# DEVIATION REVIEW AND DECISION FORM

Subdivision or Project Name: Stonebridge Filing No. 3

Section of ECM from Which Deviation is Sought: D.3 Pavement Design Criteria

RE: Stonebridge at Meridian Ranch Filing 3

Figure 1

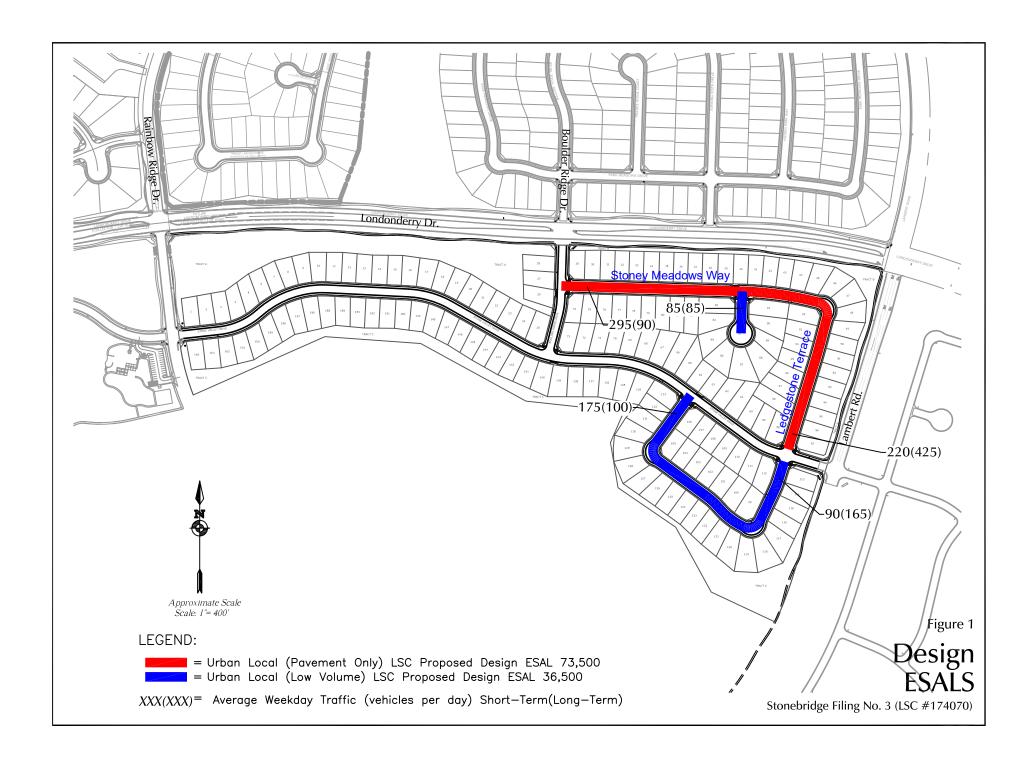
Figure 1 shows the short-term and long-term projected average weekday traffic volumes on the interior streets of Stonebridge at Meridian Ranch Filing 3. These volumes are based on the trip generation estimates and short-term directional distribution estimates shown in the February 2017 traffic impact study. The short-term total traffic volumes assume Lambert Road has not been extended south to Stapleton Drive. The long-term total traffic volumes assume buildout of the street network within the Meridian Ranch development including the extension of Lambert Road south to Stapleton Drive.
